## SUNDRY NOTICES AND REPORTS ON WELLS

Big Eddy Unit 163 30-015-35348 BOPCO, L.P. May 26, 2010 Conditions of Approval

### PROPOSED WELLBORE DIAGRAM

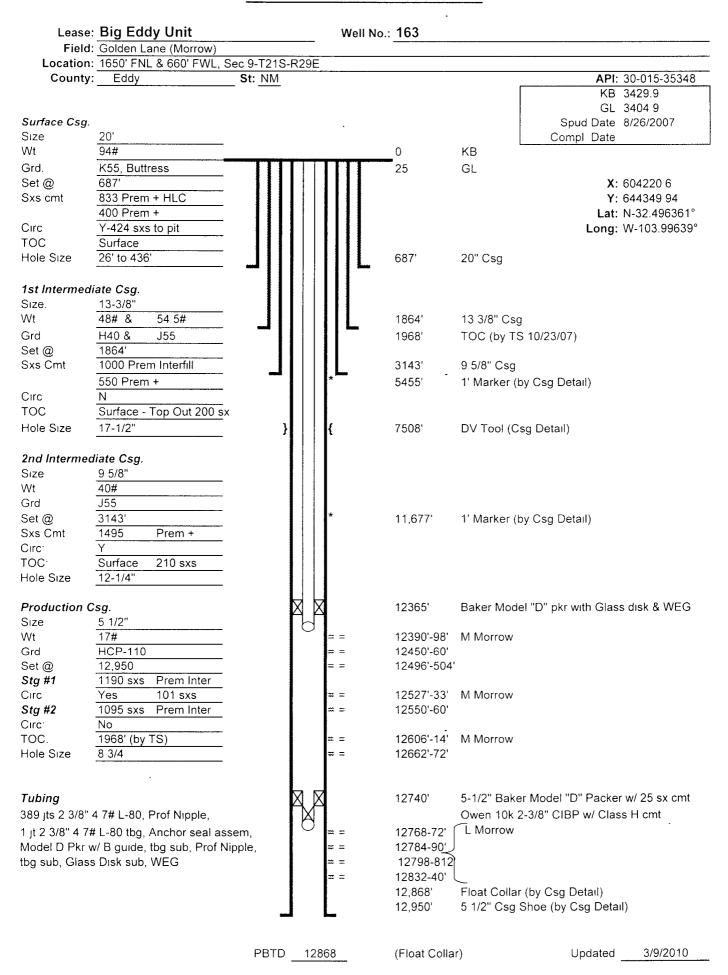
BOPCO, L.P respectfully requests permission to permanently abandon the Lower Morrow perfs @ 12,768'-12,840' by dropping an Owen 10K glass disk 2-3/8" CIBP, w/ Class "H" cmt, in the tailpipe of tbg. A 5-1/2" Baker Model "D" pkr will be set @ 12,740' & capped w/ 25 sxs cmt. Middle Morrow perfs will be added 12,672'-12,390' w/ a Baker Model "D" pkr w/ glass disk & WEG set @ 12,365'. Duncan Whitlock, of the BLM, has approved this procedure in lieu of running a MIT (originally required by the BLM as a condition of TA approval March 24, 2010).

- 1. Contact BLM 575-361-2822 a minimum of 4 hours prior to setting CIBP above Morrow perfs.
- 2. A minimum of 25 sxs of cement must be pumped on top of CIBP at 12,740'. WOC and tag at 12,510' or shallower.
- 3. Surface disturbance beyond the existing pad must have prior approval.
- 4. Closed loop system required.
- 5. A minimum of a 5M BOP is required and must be tested prior to performing operations. All blowout preventer (BOP) and related equipment (BOPE) shall comply with well control requirements as described in Onshore Oil and Gas Order No. 2 and API RP 53 Sec. 17.
- 6. Subsequent sundry with well test required.
- 7. Work to be completed within 90 days.
